Serial: BSEP 16-0024

Subject: Brunswick Steam Electric Plant (BSEP), Unit Nos. 1 and 2
Renewed Facility Operating License Nos. DPR-71 and DPR-62
Docket Nos. 50-325 and 50-324
Notification of Full Compliance with Order EA-12-049, "Order Modifying Licenses with Regard to Requirements for Mitigation Strategies for Beyond Design Basis External Events" and Order EA-12-051, "Order to Modify Licenses With Regard To Reliable Spent Fuel Pool Instrumentation" for BSEP, Units 1 and 2

Enclosure 4 provides the BSEP, Units 1 and 2, Response to NRC Request for Additional Information for Reliable Spent Fuel Pool Level Instrumentation.

3 Response to NRC Requests for Additional Information for Reliable Spent Fuel Pool Level Instrumentation

Sketch SK-89578-Z-7012

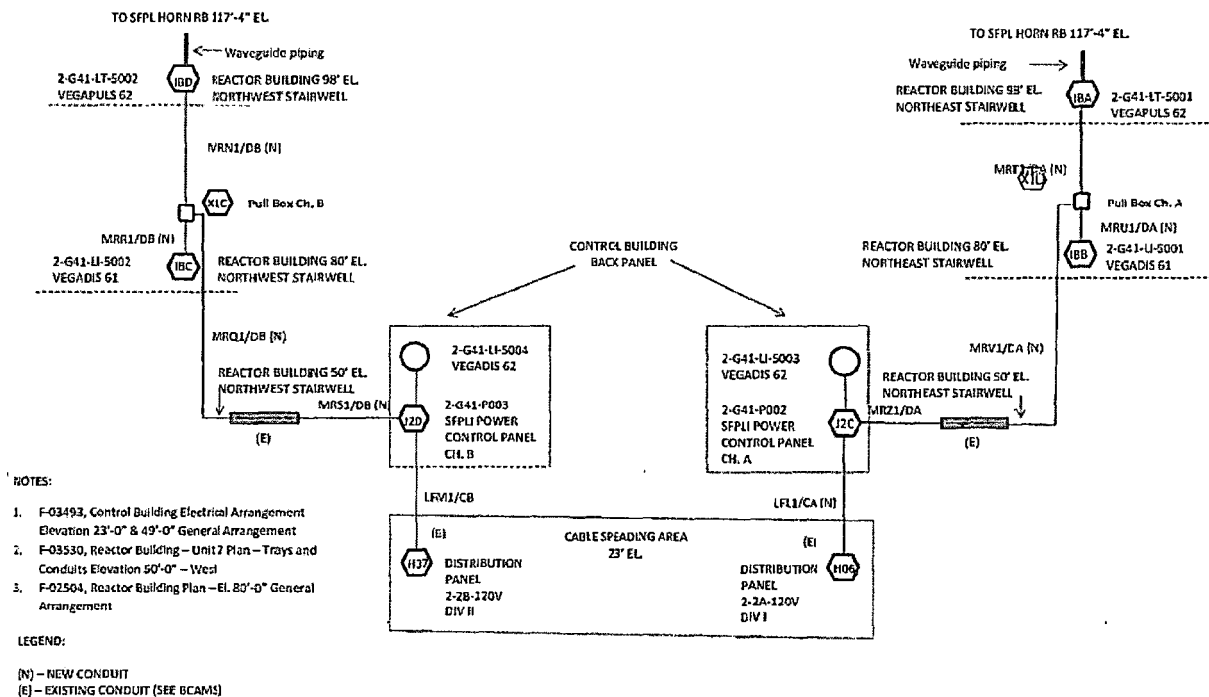
Please provide a clearly labeled sketch or marked-up plant drawing of the plan view of the spent fuel pool (SFP) area, depicting the SFP inside dimensions, the planned locations/placement of the primary and back-up SFP level sensor, and the proposed routing of the cables that will extend from the sensors toward the location of the read-out/display device.

Sketch SK-89578-Z-7012, shown below, provides the overall layout for the conduit routing. The waveguide piping is located on the 117 foot-4 inch elevation of the Reactor Building (RB), also referred to herein as the refuel floor where the SFP is located. The conduit attaches to the electronic sensor (VEGAPULS 62) located in the NE and NW stairwells at elevation approximately 98 feet. The conduit then routes to the local display (VEGADIS 61) at approximately the 80 foot elevation of the respective stairwells. The signal conduit is then routed to the RB 50 foot elevation overhead and is routed through the Reactor Building/Control Building penetrations. There are two separate sets of penetrations: Division I and Division II, where channels A and B route through separately, maintaining separation until located within the Control Room back panel. The remote displays (VEGADIS 62) is located in the Control Room back panel mounted to the South wall for Unit 2 and the North wall for Unit 1.
